Re: Submission to SSD-78996460 – 16-24 Lord Street & 21-27 Roseville Avenue, Roseville

SJB Planning has been engaged by the Eastside Roseville Action Group Inc. (ERAG) to review the proposal and prepare a submission. We act on behalf of ERAG and write to formally object to the proposal.

Figure 3: Extract of the West Elevation, Drawing No. SSDA-201 including SJB Planning mark-ups of building length (Source: FKA)

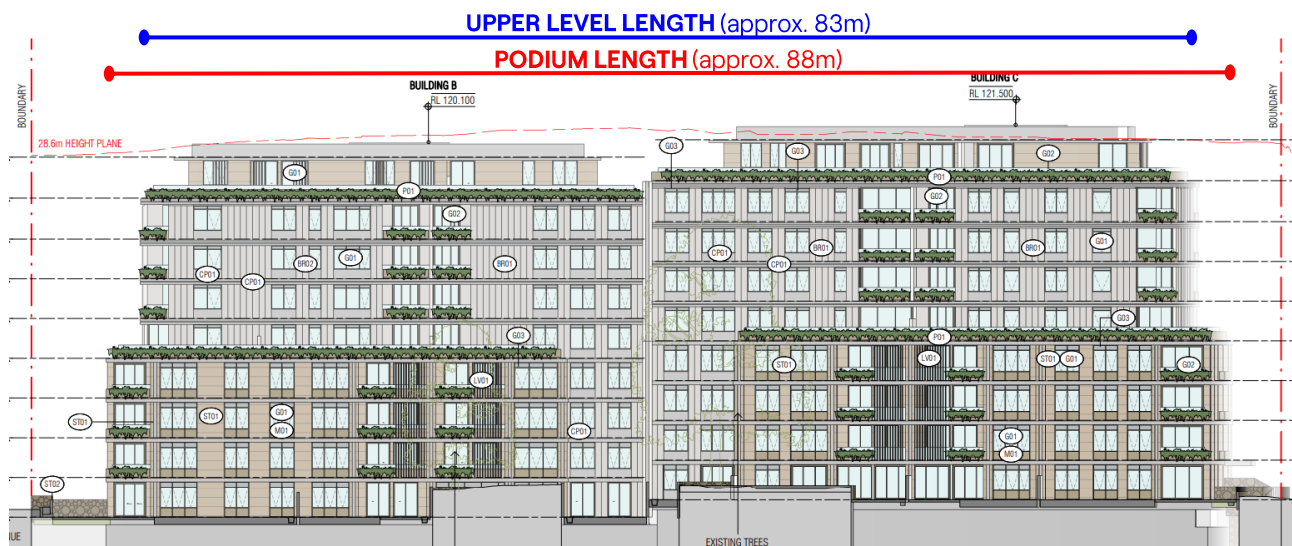
The western podium interface of the proposed building footprint is approximately 88m in length and directly faces low density residential development adjoining to the west. At its upper levels, the western side of the building is approximately 83m in length (refer to Figure 3).

Along its 88m length, the western podium interface presents a minor 3m recess in the centre of the site. This minor element is unlikely to be able to be “read” from the properties and dwellings adjoining directly to the west as they are situated adjacent to the northern and southern portions of the building, not the centre (refer to Figure 4). The western elevation of the upper levels above the podium provides no additional recess other than the 3m upper level setback.

Figure 4: Extract of the Level 3 Plan, Drawing No. SSDA-103 including SJB Planning mark-ups (Source: FKA)

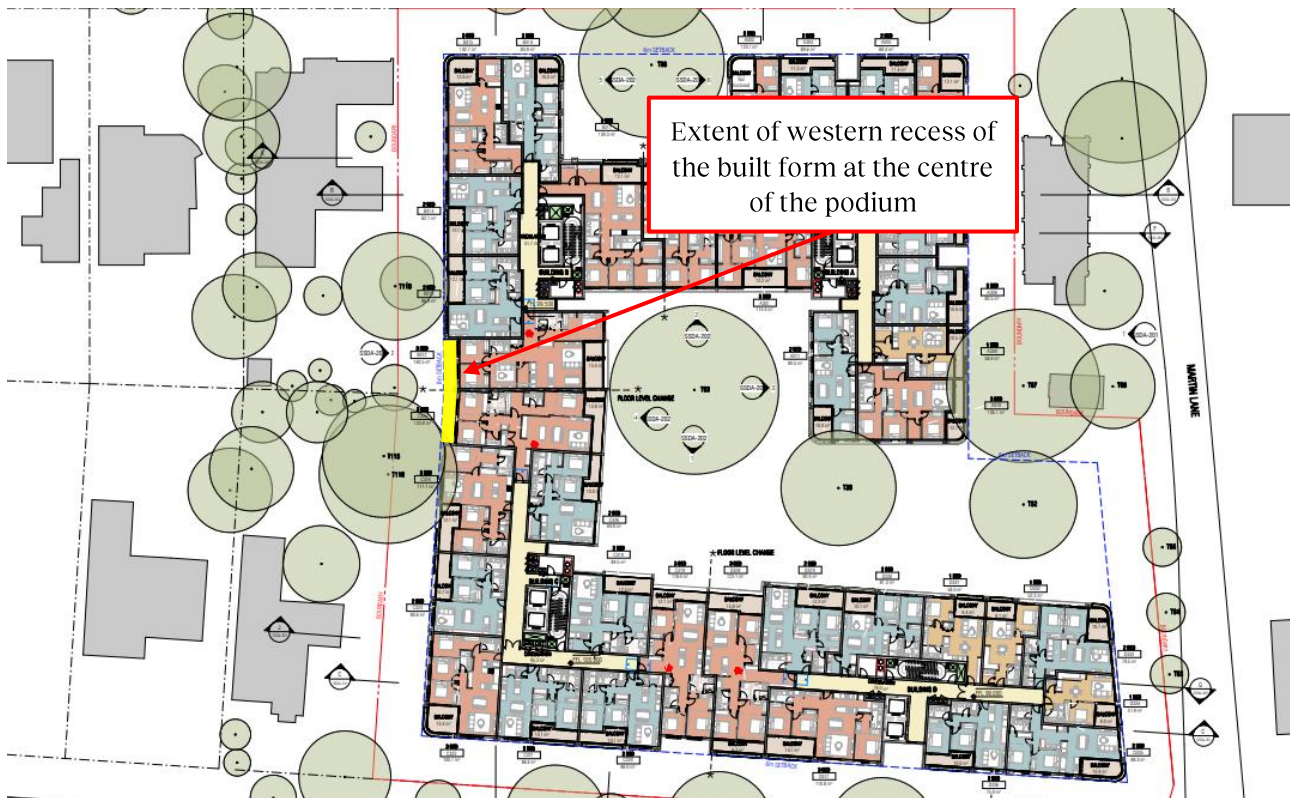
The western elevation presents as an eight storey wall, with inadequate breaking down or separation of the horizontal form to provide visual relief for properties to the west. The footprint also follows the consolidated western boundary at an obtuse angle (less than 180°) which will contribute to an even higher sense of enclosure for adjoining properties.

Figure 6: Extract of the North Elevation, Drawing No. SSDA-200 (Source: FKA)

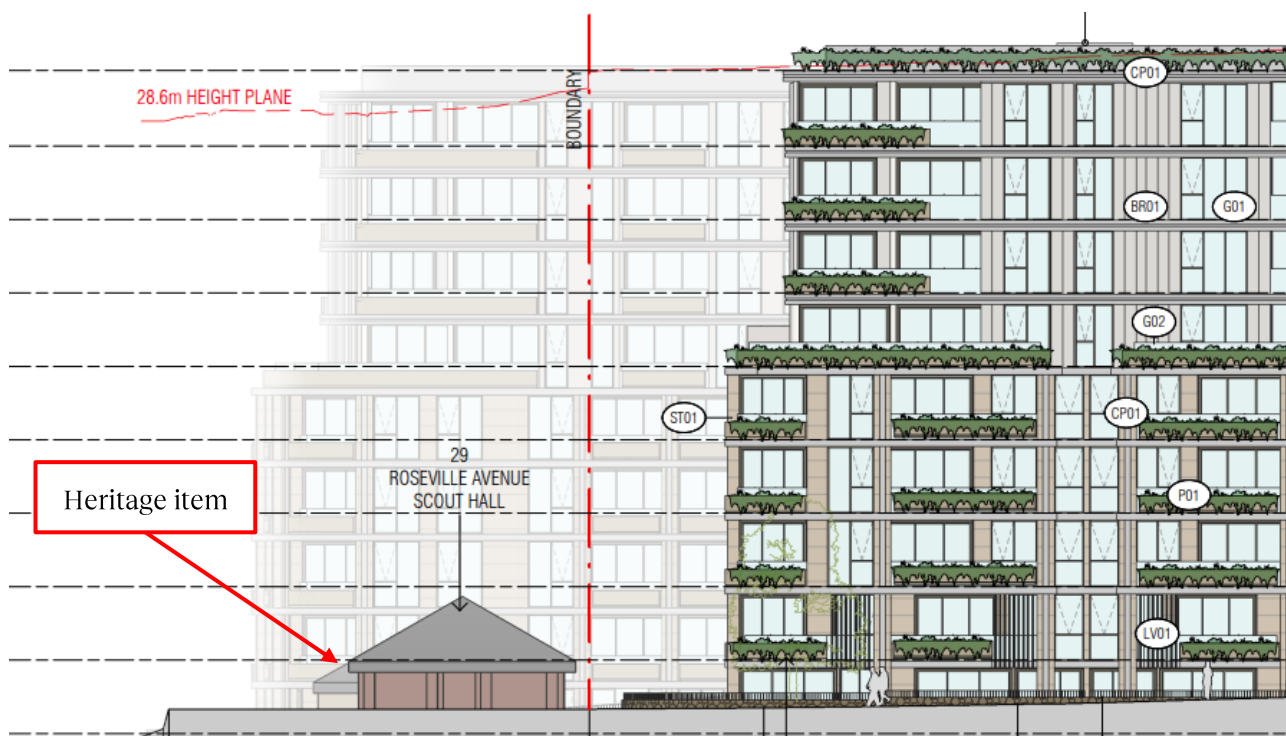
As it stands the Scout Group Hall building is seen in a low rise context with buildings of a similar scale and period of construction. The proposed elevational drawings (refer to Figures 6 and 7) demonstrate that the Scout Group Hall building will be viewed in relation to the northern and eastern podium facades of the proposed Building A and, to a lesser extent, the northern podium façade of Building D at its rear.

Figure 20: Extract of the Potential Development under Housing SEPP within the TOD Area Diagram (Source: FKA)

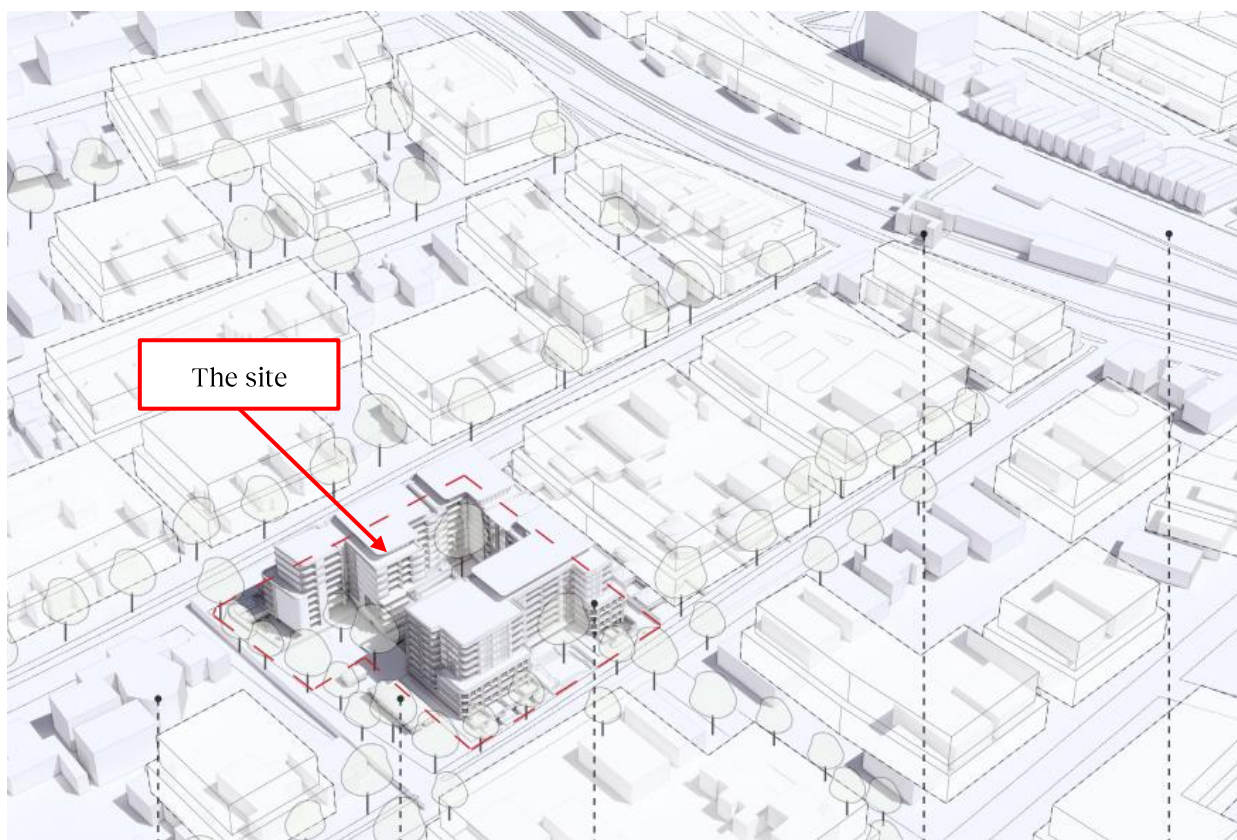
The proposal envisages a blanket uplift for the majority of the surrounding area that would result in the proliferation of residential flat buildings (potentially with in-fill affordable housing bonuses included) presented by the current planning provisions.

Figure 24: Extract of the GFA Diagrams - Sheet 01, Drawing No. SSDA-410 Rev A including SJB Planning mark-ups of missed GFA areas on Lower Ground and Ground Level highlighted in yellow and dashed in blue (Source: FKA)

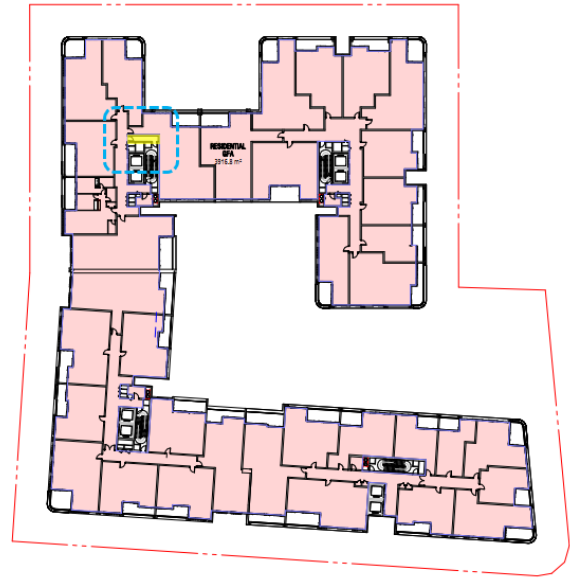
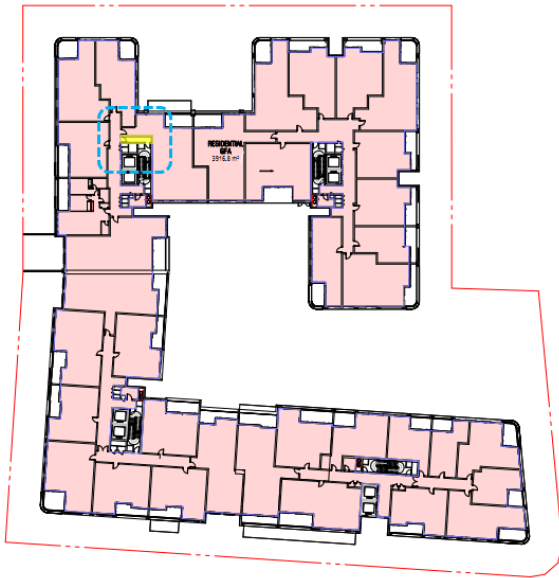
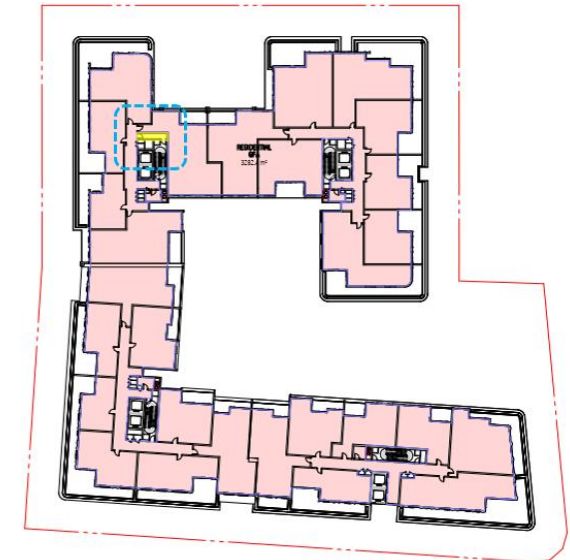
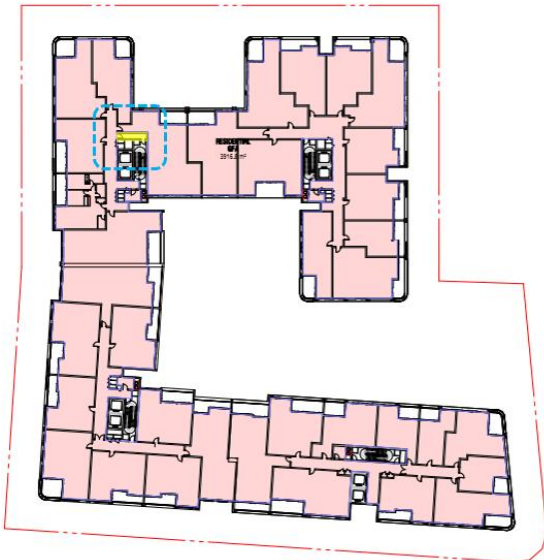
The GFA Calculation Plans submitted with the application have not included all areas required to be calculated. These missed areas are shown in Figures 22 to 26 and include horizontal circulation areas that are not otherwise excluded from the definition.

Figure 30: Extract of the Lower Ground GFA Diagram, Drawing No. SSDA-410 including SJB Planning mark-up of areas subject to GFA clarification (Source: FKA)

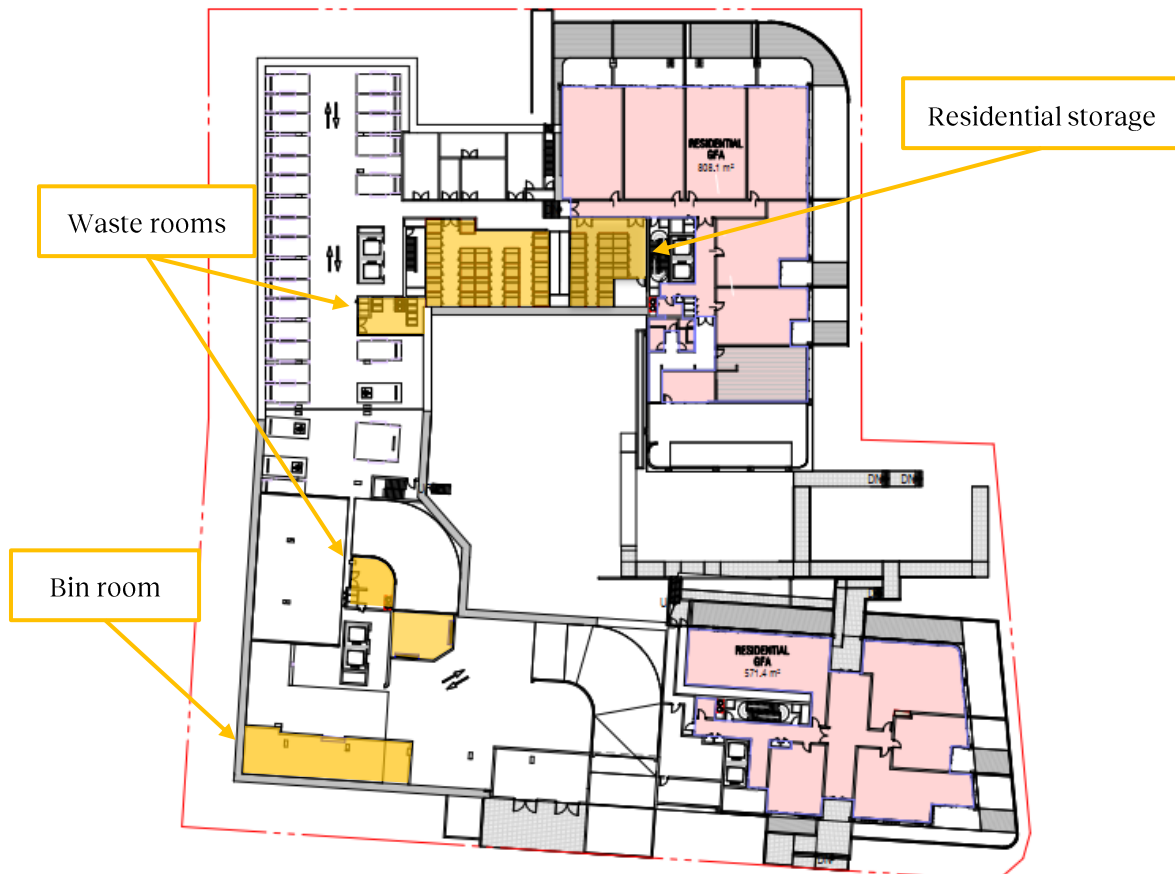
Figure 30 identifies garbage and storage areas within the proposed lower ground floor plan that would be captured as GFA if they are not located in the “basement”, which is defined as follows:

Should the consent authority find that these areas are to be captured in GFA calculations, a Clause 4.6 Request to Vary a Development Standard in relation to the floor space ratio (FSR) may be required.

Figure 31: Extract of the Deep Soil Zone Plan, Drawing No. SSDA-425 Rev A (Source: FKA)

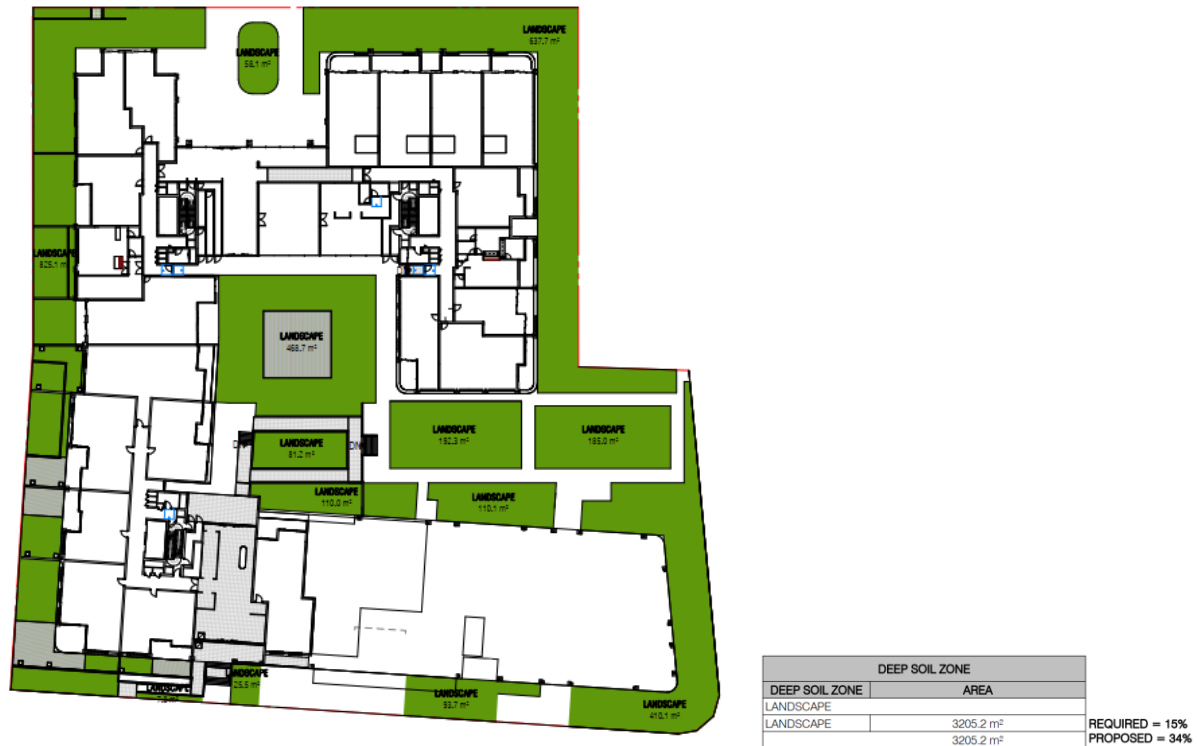
The Deep Soil Zone Plan within the Architectural Plans includes a diagram and a table with calculations of the “deep soil zone” (refer to Figure 31). This drawing states that the area is 3,205.2m², or 34%.

The applicant’s calculation of deep soil areas appears to include areas that, based on the landscape drawings, are clearly not deep soil areas as they include structures, with a snapshot shown in Figure 32 below.

Figure 32: Extract of the Landscape Ground Plan (Source: Land and Form)

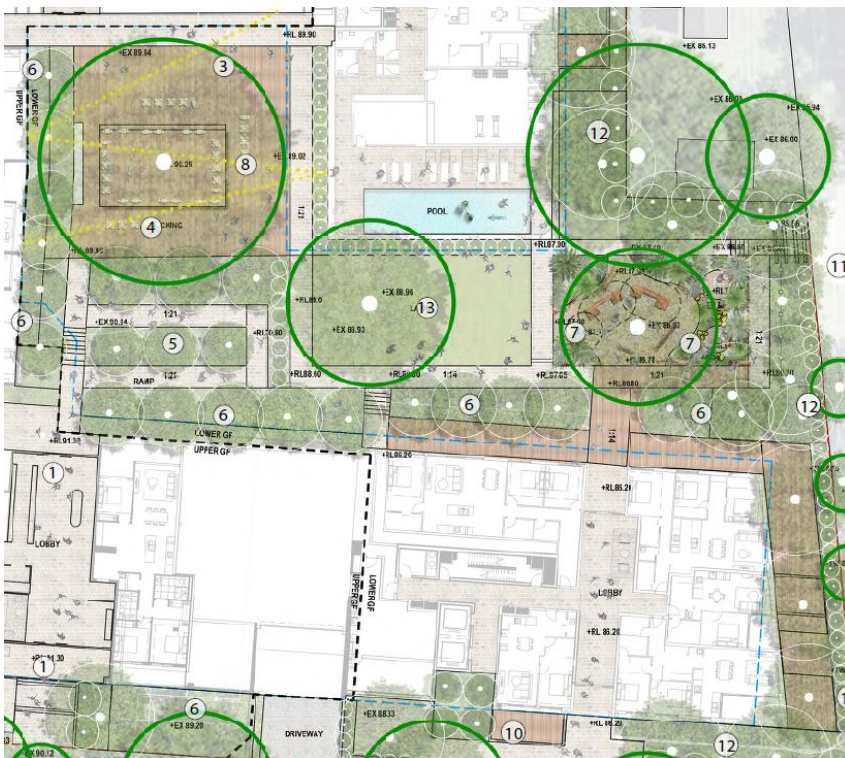
There is inconsistency between the architectural, landscape and planning documents submitted with the proposal and based on our assessment none, either individually or collectively, can be relied upon for the accurate calculation and assessment of landscaped area and deep soil areas.
